ADDENDUM #4

07/24/2014

**TO PLANS AND SPECIFICATIONS FOR
RENOVATION AND ADDITION TO
FT. SAM HOUSTON ELEMENTARY SCHOOL
&
RENOVATION AT COLE HIGH SCHOOL**
Ft. Sam Houston
San Antonio, TX

SHEET TITLE:
CONCRETE SECTIONS

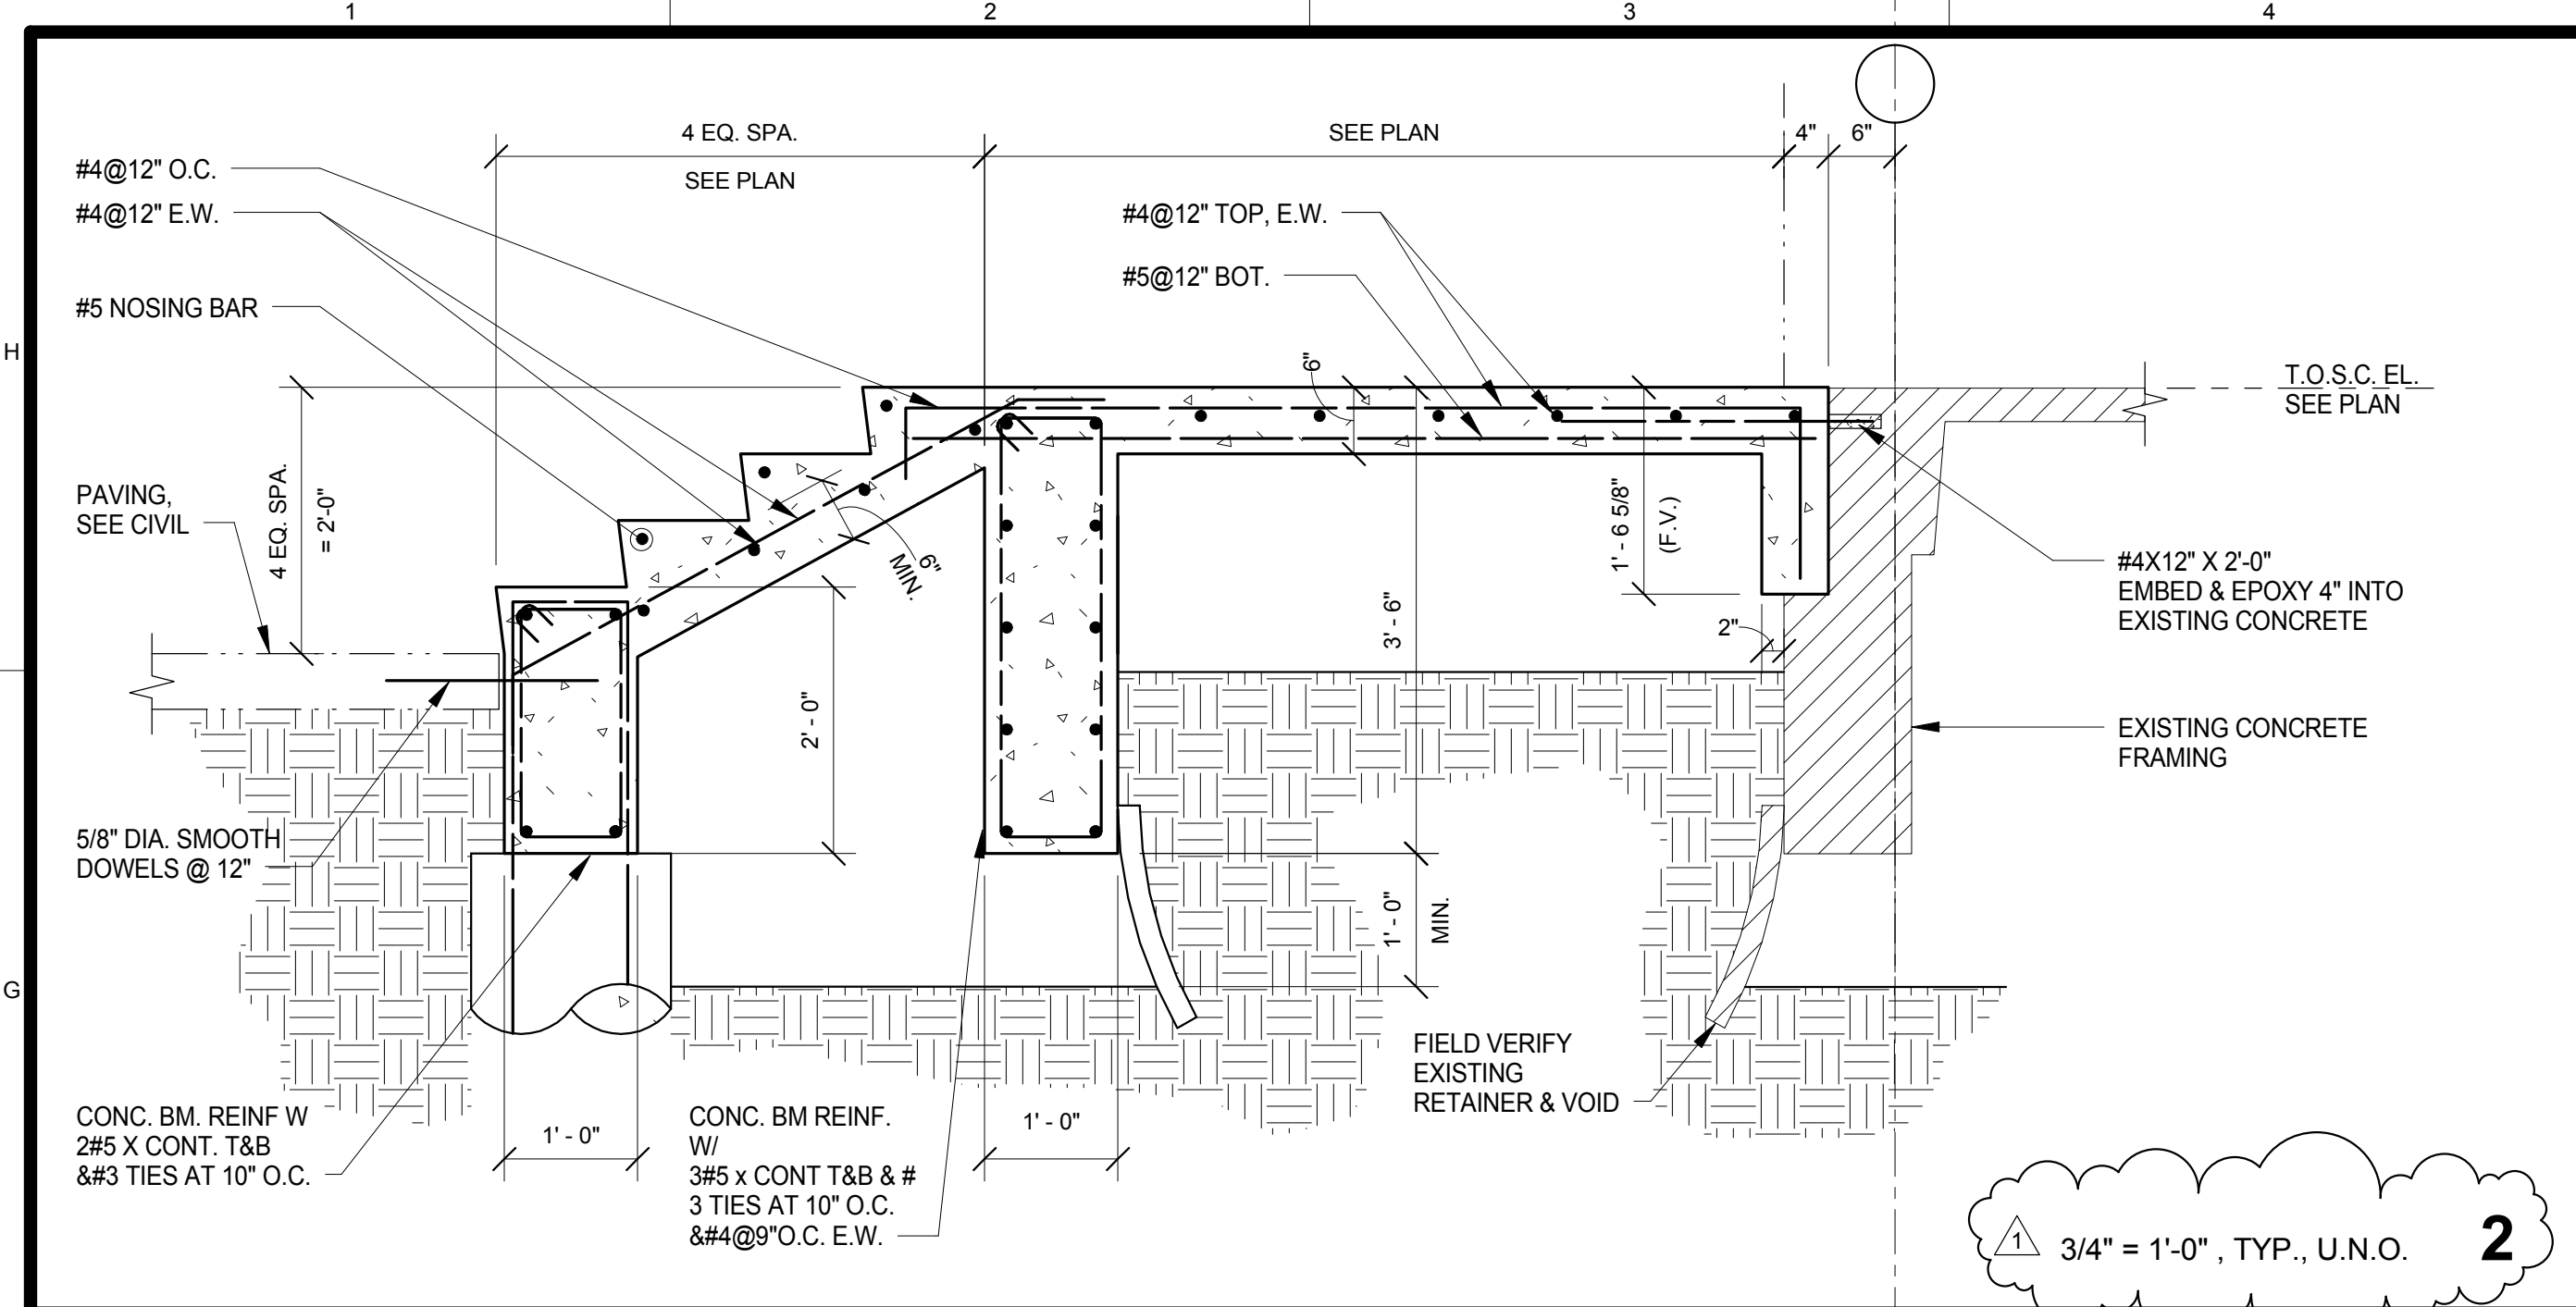
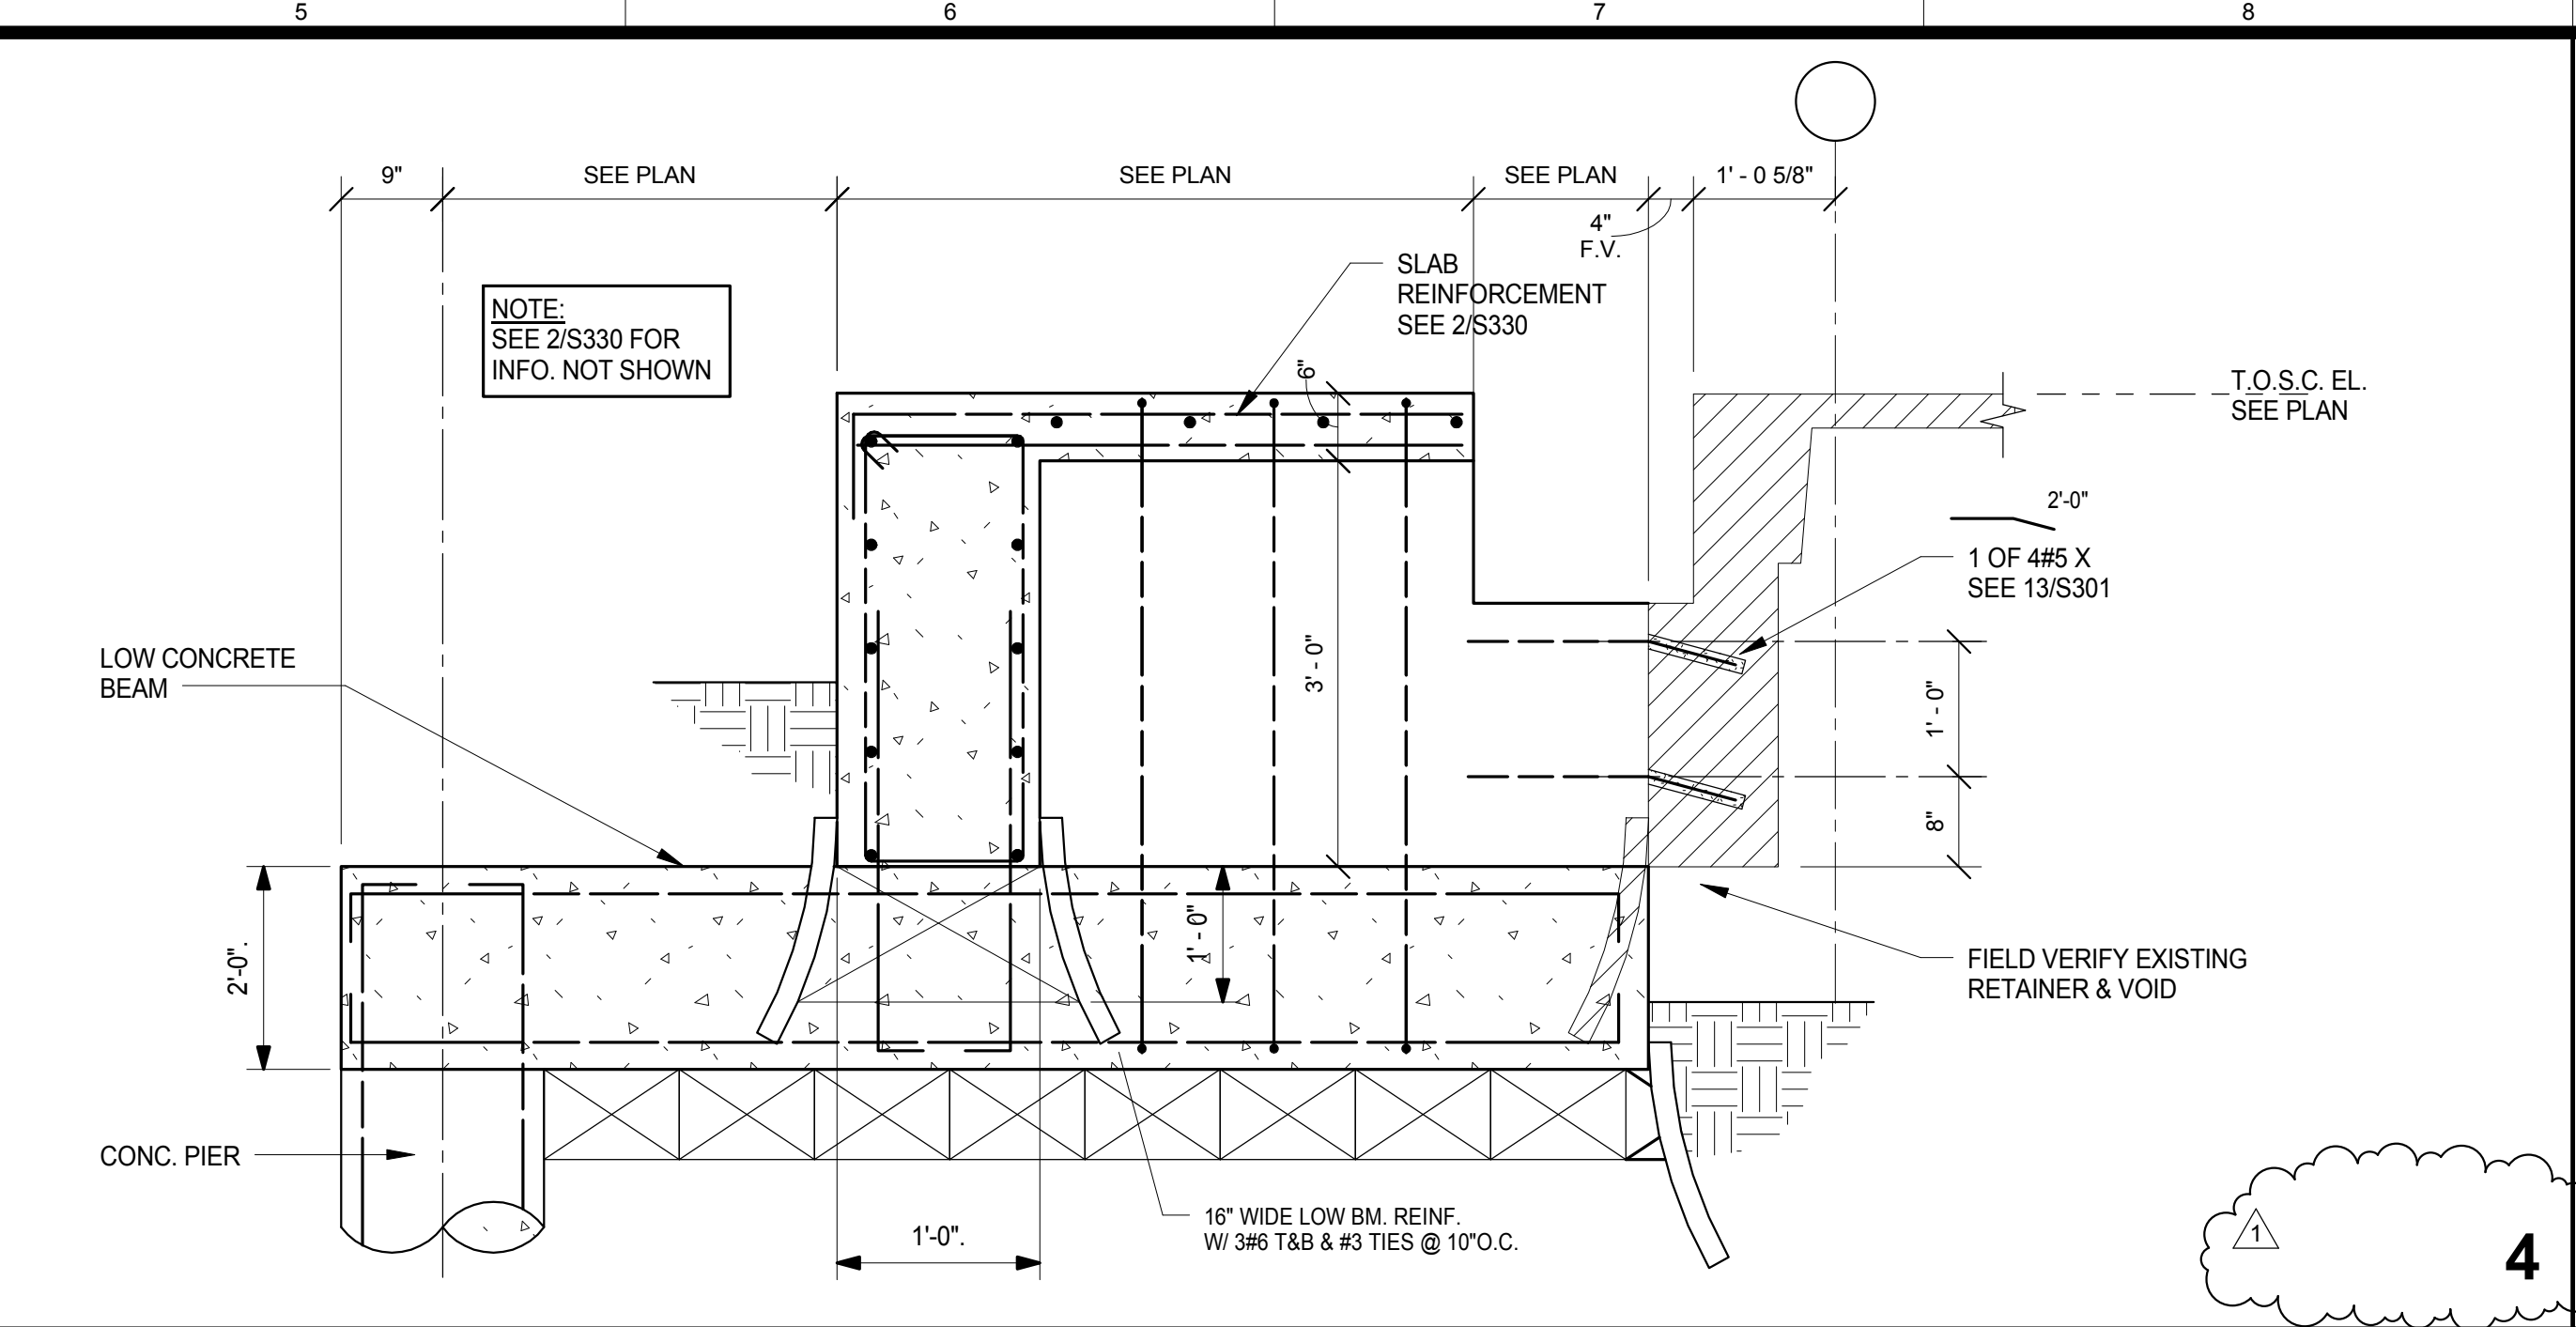
- A. Sheet S300:
 - a. See revised sheet for changes to typical pier detail and pier schedule.
- B. Sheet S310
 - a. See revised sheet for clarifications to grade beam reinforcing.
